Work Order ID 132169

Item Name: Aft Crosstube - High 407

Reference: REWORK PER ECN 15-557

DRAWN	RF	HAWKESBURY, ONTARIO, CANADA	
CHECKED	9	DRAWING NO.	REV. G
MFG. APPR.	9	D407-667-245	SHEET 1 OF 4
APPROVED	9	TITLE	SCALE
DE APPR.	9	CROSSTUBE ASS'Y (407 HIGH AFT)	NTS
DATE	15.03.20	COPYRIGHT © 2002 BY DART AEROSPACE LTD THIS DOCUMENT IS PRIVATE AND CONFIDENTIAL AND IS SUPPLIED ON THE EXPRESS CONDITION THAT IT IS NOT TO BE USED FOR ANY PURPOSE OR COPIED OR COMMUNICATED TO ANY OTHER PERSON WITHOUT WRITTEN PERMISSION FROM DART AEROSPACE LTD.

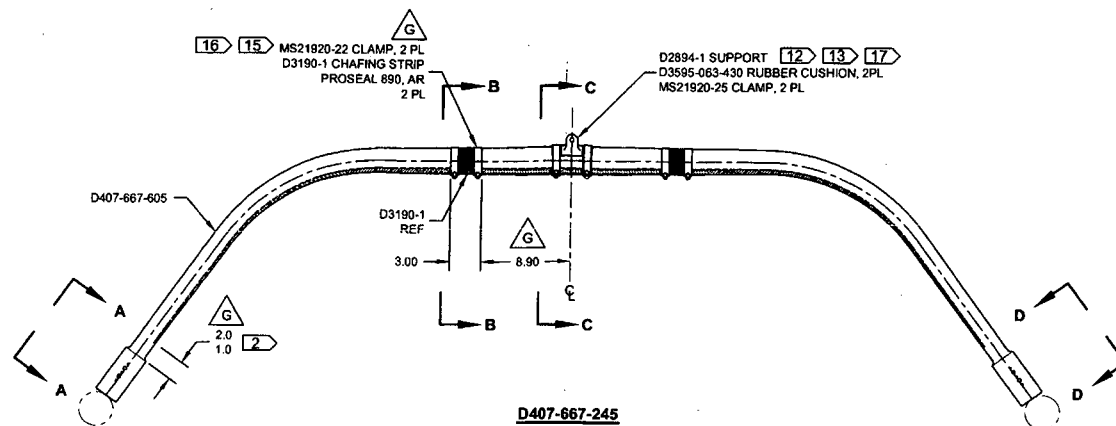
G	INCORP. DEO'S D407-667-245-F1-F2 (ZN D8-1, A8-1, D5-2, B6-2, C6-2); 8.90 WAS 8.53 (ZN D5-2); TORQUE REDUCED FOR CHAFING SHIELD (ZN A8-1); FINISH REVISED TO ALLOW MANUFAC. FLEXIBILITY (ZN C8-1)	RF	15.03.20
F	REFORMAT NOTES TO NEW STANDARDS (ZN B8-1); RELOCATED FLAG #6 (ZN A8-3) PER NCR 210; REMOVED REF. & ADD TOLERANCES (ZN C6-3, C4-3 & D2-3)	RF	08.11.06
E	8.02 AND 8.53 WERE 8.40 AND 8.90 (ZN D5-2); REORGANIZED VIEWS AND REFORMATED DRAWING TO CURRENT STANDARDS. REASONS: CLAMPS MOVED 0.375 TOWARD CL TO ELIMINATE INTERFERENCE WITH AIRCRAFT MOUNTS. REFERENCE: PAR#08-21 AND ECN#1225	MB	08.07.24
D	ADD VIEW FOR OEM SKID HOLES, ROTATE ORIENTATION OF CLAMPS SECTION F-F, REMOVE -851 ABRASION STRIP, ADD MAGNOBOND 6398, ADD CUSHION	PH	07.02.07
C	ADD HOLES AND NUT PLATES FOR COMPATIBILITY WITH BHT/AA SKIDTUBES	PH	05.07.28
B	ADD CHAFING SHIELD	CP	03.05.21
A	NEW ISSUE	CP	02.05.13
REV.	DESCRIPTION	BY	DATE
DESIGN	9	DART AEROSPACE LTD

NEEDS TO BE REWORKED PER ECN 15-557

REMOVE CHAFFING SHIELDS AND CLAMPS (MS21920-22)
AND SCRAP

Paint B#132024
REPLACE WITH NEW PER NEW DRAWING REV G

1- Install chaffing shield as per D407-667-245 using DT10096 to establish 8.90
dimension. Top holes should be facing up.

****Ensure chaffing is to be position "overlap" AFT****
